Design Relaxation Request

City Project 702620

Superior Street & Interstate 180 East Ramp Safety Project

Lincoln, Nebraska

PROJ: 702620.dwg
 PEN: ..\users\pen\BW_PENTABLE.TBL
 USER: 6/6/2010
 DATE: 8/12/2010
 DGN: ...702620 Release Attachment 1.DGN

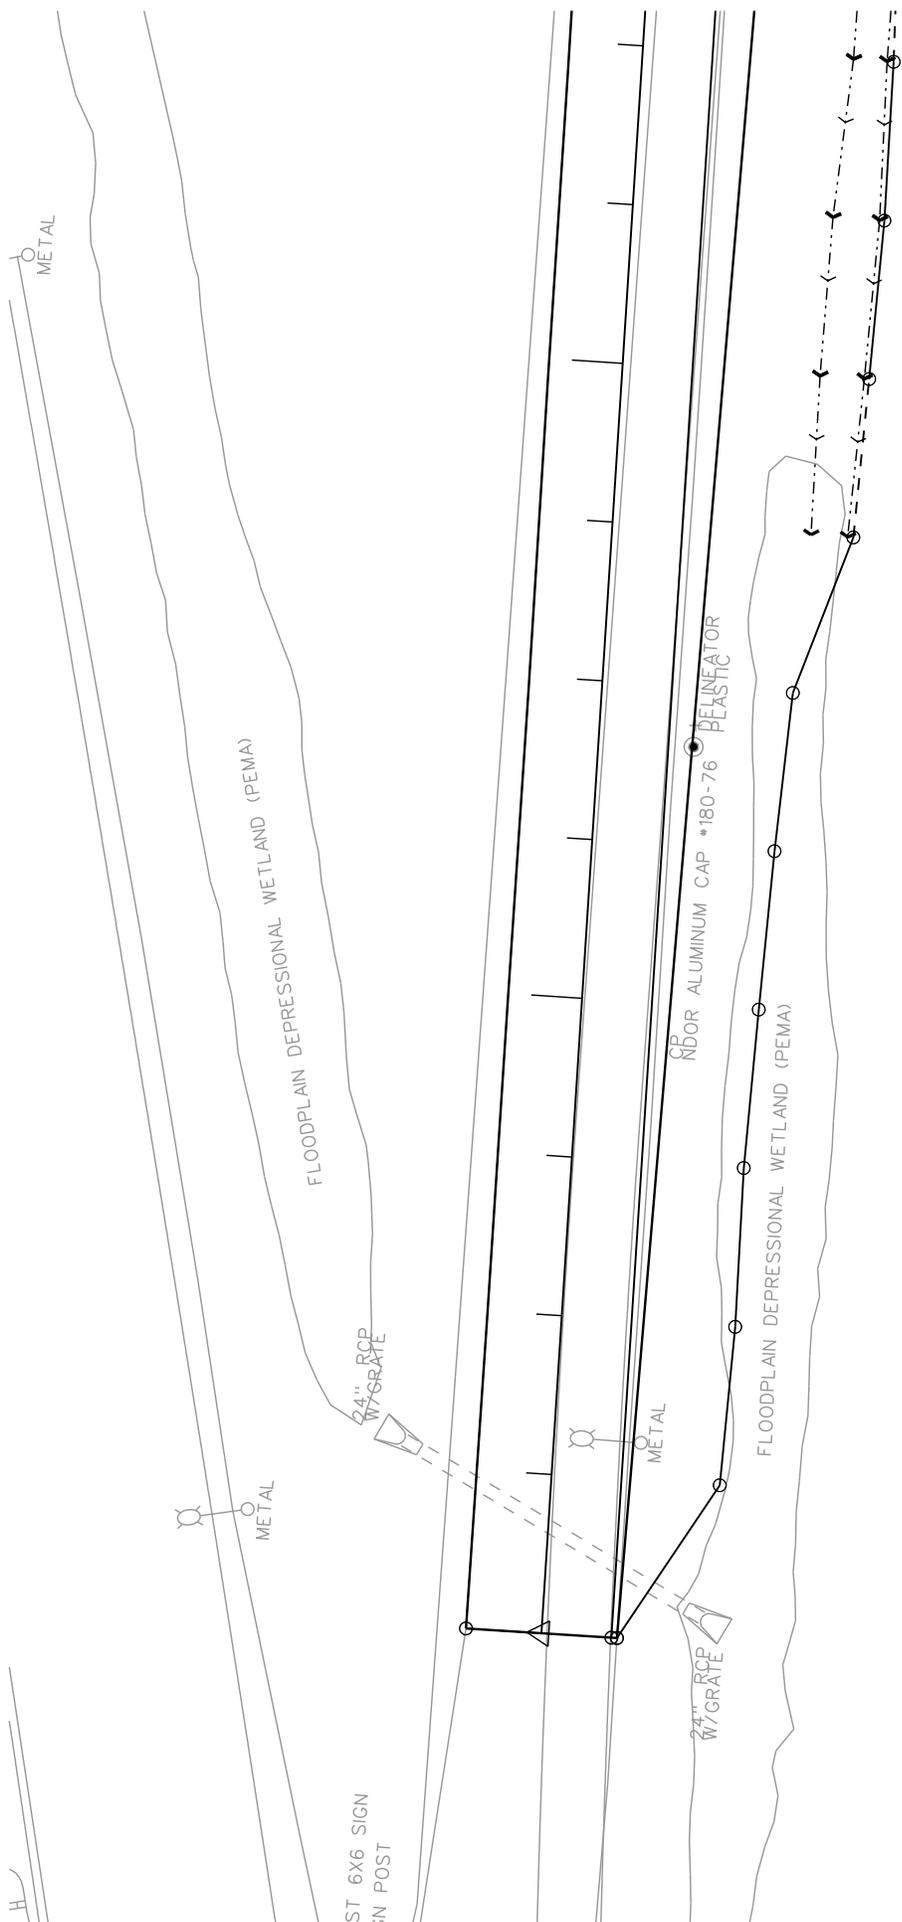
The 2002 *Board of Public Roads Classifications and Standards Minimum Design Standards for Municipal Streets* shows a minimum required foreslope of 1V:6H for “Interstate Interchange Ramp”. The City of Lincoln is requesting a relaxation of the minimum foreslope requirement of 1V:6H to 1V:3H for 225 feet at the south end of the ramp reconstruction.

The need for the relaxation from the minimum standard is due to a delineated Floodplain Depressional Wetland (PEMA) which is located on the east side of the off-ramp near the entrance from Interstate 180. The reconstruction and widening of the ramp will require new earth shoulder grading, 1V:6H foreslopes (fill condition) and drainage ditch grading. As shown in Attachment 1, the limits of grading with the required 1V:6H foreslope (Limits of Construction) will directly impact the wetland as it currently exists. By allowing a 1V:3H foreslope and a matching into the existing slope and drainage ditch, for 225 feet on the south end of this project, the impacts to the wetland can be avoided, as shown in Attachment 2. Construction impacts to wetlands can disturb the environmental stability of an area and will also cause added delays and expense in the design and construction phases of this project.

NOTE:
 LIMITS OF CONSTRUCTION SHOWN
 ARE WITH 1V:6H FORESLOPE

PROJ: 702620.dwg
 PEN: ..\public\pen\BM_FENTABLE.TBL
 USER: g...
 DATE: 8/12/2010
 DGN: ...702620 Release Attachment 2.DGN

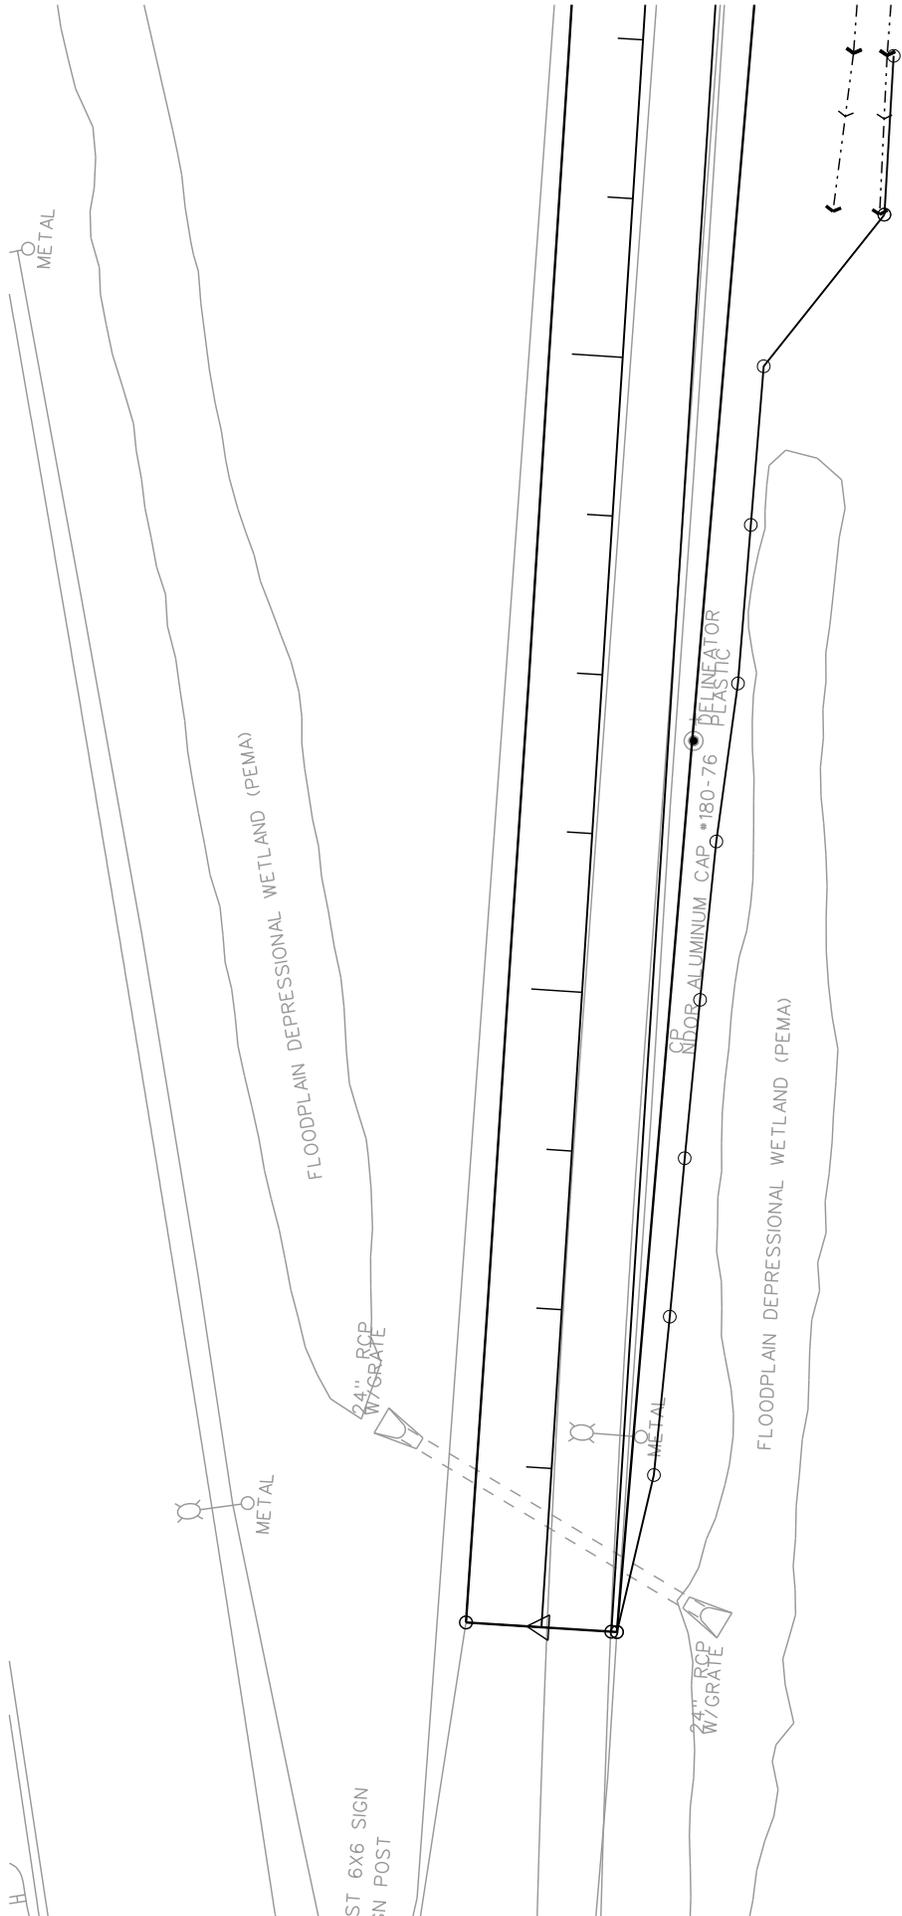
The additional fill material and grading will be less than 1 foot in depth in this area and 1V:3H slopes will not impact the safety of traveling motorists on this facility. AASHTO’s *2002 Roadside Design Guide*, indicates that foreslopes of 1V:3H are considered traversable if they are smooth and free of fixed objects. An existing street light pole is located in the area of grading on the south end of the project. However, this pole will not be relocated as part of this project and will be located within the 2% earth shoulder grading for the new roadway section and not on the 1V:3H foreslope. AASHTO’s *2002 Roadside Design Guide* also states that most vehicles on 1V:3H foreslopes will continue to the bottom of the slope and thus a clear runout area beyond the catch point is desirable. An existing 10 foot flat bottom ditch is present beyond the toe of the foreslope and runs the length of the proposed relaxation area. This ditch will provide an adequate runout area for errant vehicles. An example cross section showing the proposed 1V:3H foreslope and existing 10 foot flat bottom ditch runout area can be seen in Attachment 3.

NOTE:
 LIMITS OF CONSTRUCTION SHOWN
 ARE WITH 1V:3H FORESLOPE

Since the proposed foreslope falls within acceptable parameters without compromising safety to the travelling public, the City of Lincoln respectfully requests a relaxation of the Board’s foreslope standards for the Superior Street & Interstation 180 East Ramp Safety project.
